TEXAS UTILITIES GENERATING
COMPANY, et al.

(Comanche Peak Steam Electric Station
Station, Units 1 and 2)

CASE'S ANSWER TO APPLICANTS' REPLY TO CASE'S ANSWER TO
APPLICANTS' MOTION FOR SUMMARY DISPOSITION
REGARDING CONSIDERATION OF FRICTION LOADS

AFFIDAVIT OF CASE WITNESS MARK WALSH

FIGURE 1

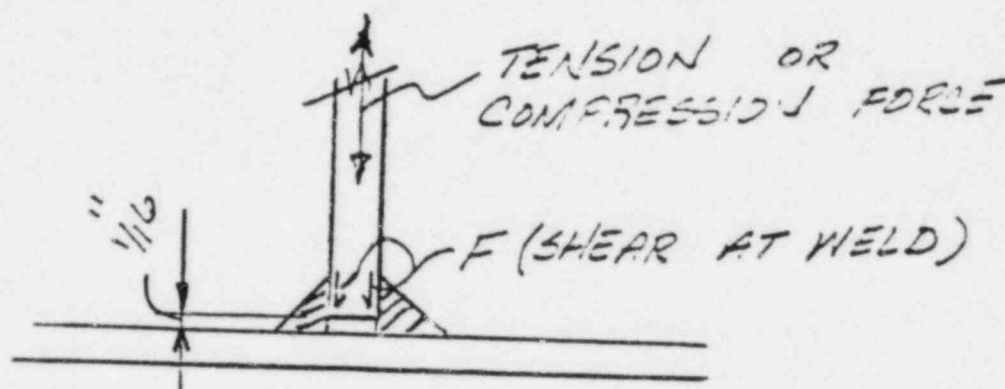
The capacity of the weld actually must be based on a shear stress between the weld and the base metal. This is a requirement of the AISC code, 7th Edition, Supplement No. 3, as indicated in Table 1.5.3. (to which Applicants are committed), as indicated under "Fillet Welds." (See Attachment A hereto.) The load is transferred through shear from the base metal to the weld, and therefore, all the normal forces, designated as F_n on line 12 of the calculation, must be additive. This additive effect need not be in the code (although it is), but based on engineering judgement, it

would have to be additive. As shown in Figure 1 below, there is a gap between the base metal and the attaching member. This gap is normally found in the field and is acceptable up to $1/16$ "; i.e., there will be no nonconforming conditions if a $1/16$ " fit-up gap is inspected prior to welding. Since the force from the attaching member must pass the load by shear through the weld (designated by F in the diagram below), it is easily seen that whether the load is axial compression or tension is of no importance in this regard.
